**Re: W2007L2-0003 Part B Item 2c – Reduction to Security Deposit**

**Supporting Information  
DDMI Request for a Reduction to the Security Deposit  
(W2007L2-0003 Part B Item 2c)  
October 28, 2011**

DDMI Response to Information Request October 13, 2011

**Figure 1.** Conceptual Preferred Plan (ICRP V3.0): Rock pile closure – DDMI Presentation to AANDC November 9, 2010.

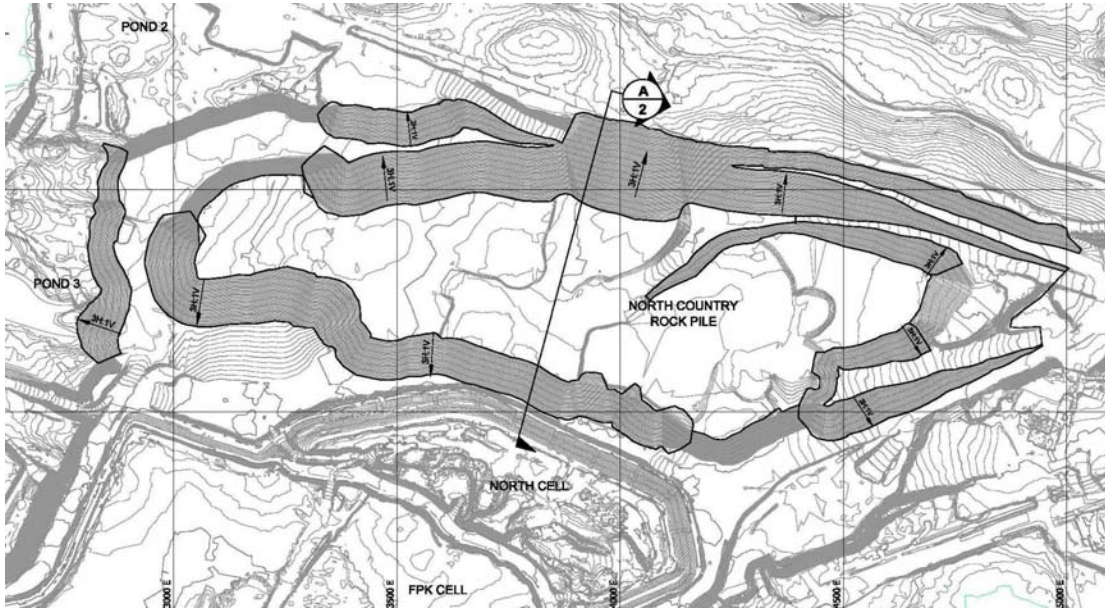
*Based upon DDMI's figure of the NCRP (extracted from Dec 2010 Powerpoint presentation shown below as Fig 1), essentially all of the perimeter of the pile is composed of Type 2/3 rock. Without clarification from DDMI, it must be assumed that all of the interior of the pile is the same blend of rock types." (AANDC, 2011)*

*“Based upon DDMI’s figure of the NCRP (extracted from Dec 2010 Powerpoint presentation shown below as Fig 1), essentially all of the perimeter of the pile is composed of Type 2/3 rock. Without clarification from DDMI, it must be assumed that all of the interior of the pile is the same blend of rock types.” (BCL April 15, 2011)*

Figure 1, that is referenced above, is provided below. For context the Figure was presented by DDMI as a “Conceptual Plan: Rock pile closure” in initial discussions with AANDC/BCL November 9, 2010.

Figure 1 shows areas of the NCRP where re-sloping was proposed, based on the previous ICRP V3.0 DDMI preferred design, for “Exposed type 2 & type 3 slopes”. This design was subsequently not approved by the WLWB.

**Figure 2.** As-built configuration for North Country Rock Pile to July 30, 2010. Type I rock is pink, Type II rock is blue and Type III rock is yellow.

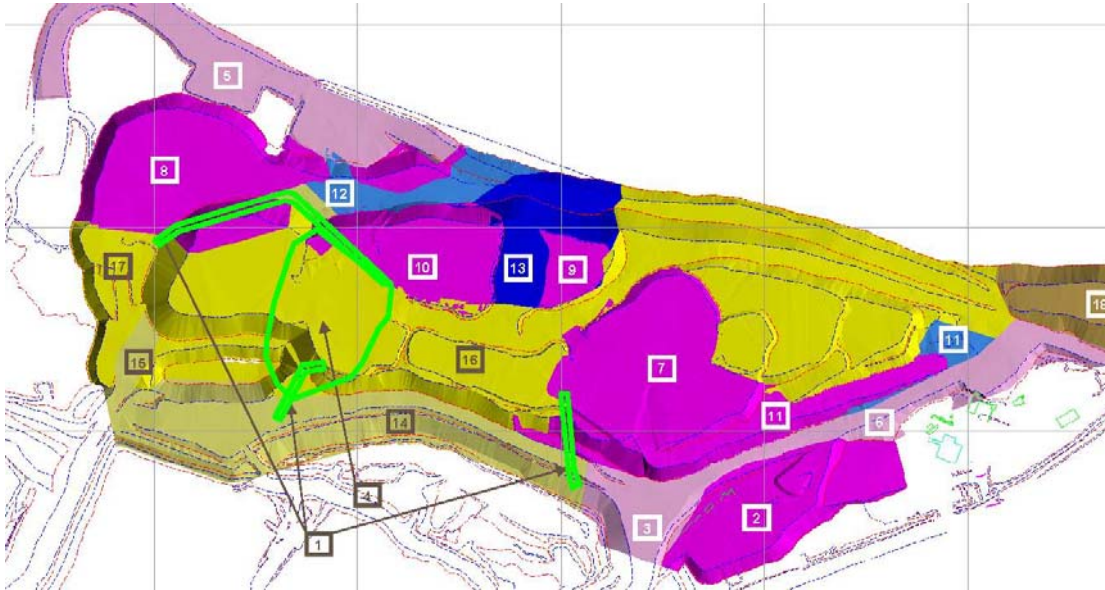
This confusion around area 10 (Figure 2) was identified as an area of concern in discussions with AANDC and BCL on Sept 16, 2011. The concern was raised with regard to the presentation of a re-mining plan for the NCRP made by DDMI to WLWB, AANDC and BCL on June 29, 2011. Figure 4 shows the areas in the NCRP suggested by DDMI that could be targeted for Type I re-mining.

Figure 2 shows the as-built configuration for the NCRP to July 31, 2010 and delineates areas by waste rock type. The area labeled “10” in Figure 2 is Type I rock, however in Figure 1 this area is shown as being re-sloped. DDMI apologizes for this confusion and **requests that Figure 2 be used by BCL to delineate the locations of Type I within the NCRP** instead of the assumption that it is all a Type II/III blend based on Figure 1.

The Type I areas shown in pink in Figure 2 contain a total of 37 Mt (18 Mm<sup>3</sup>) of Type I rock to July 31, 2010. The volumes and tonnages of Type I rock by area are shown in Table 1.

**Figure 4.** Conceptual Re-Mine Plan to demonstrate how Type I rock can be extracted from the NCRP for use in mine closure. (From WLWB-AANDC-BCL Meeting June 29, 2011).

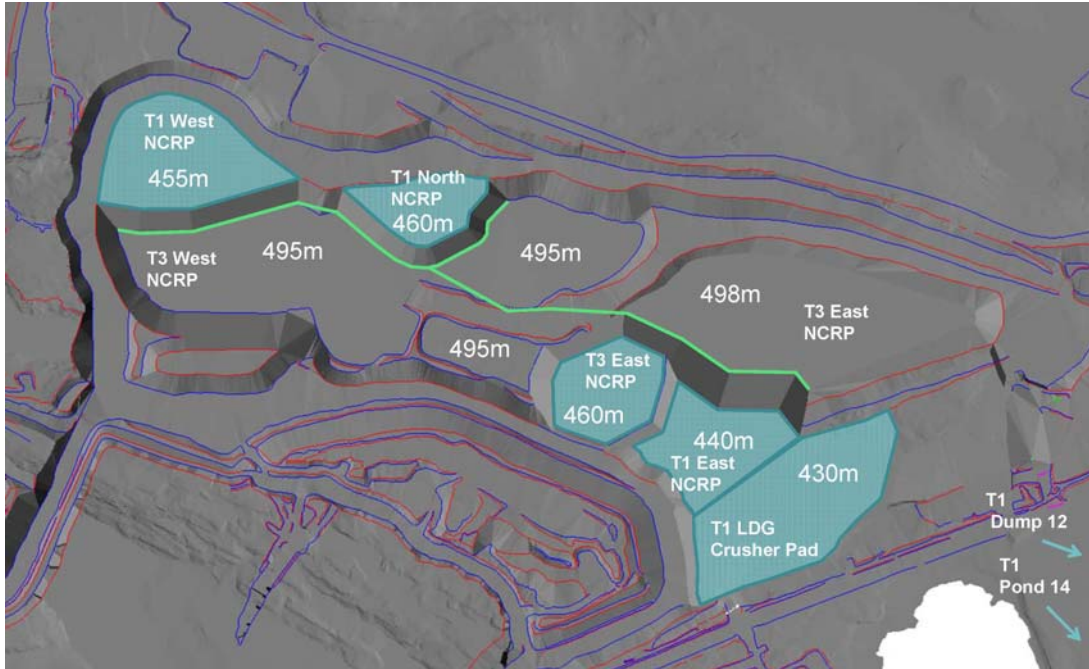
The specific concern raised by BCL was the rock type that exists in the area in Figure 4 titled "T1 North NCRP 460m". This is the same as the area labeled "10" in Figure 2 and is Type I rock. Table 1 shows that there were 4 Mt of rock in area "10" at July 31, 2010. The re-mine plan for the "T1 North NCRP 460m" shows extraction of 2.4 Mt of the 4 Mt available in this area. It shows mining of only the upper level to the 460m level.
